**Re: Defect Information Report – Supplemental Report No. 6  
11V-193, FL-588, Sterling Bullet Left Tie Rod Ends  
Revised Dealer Notice**

## Subject: Sterling Bullet Left Tie Rod Ends

April 2011  
FL588A  
NHTSA #11V-193  
Transport Canada #11-011  
REVISED NOTICE

Fig. 3, Measuring Tie-Rod End Angle

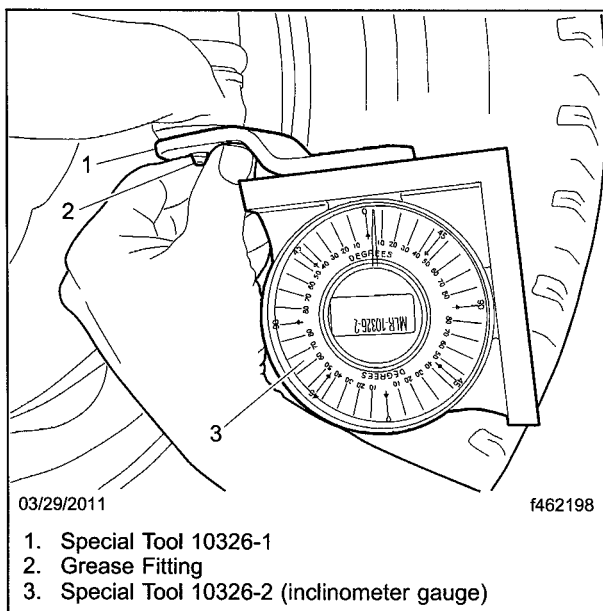
**REVISION:** A missing decimal point has been added to the "Important" note above step 25. It now reads, "IMPORTANT: Toe should be set to +0.20 degrees total."

**IMPORTANT:** Toe should be set to +0.20 degrees total.
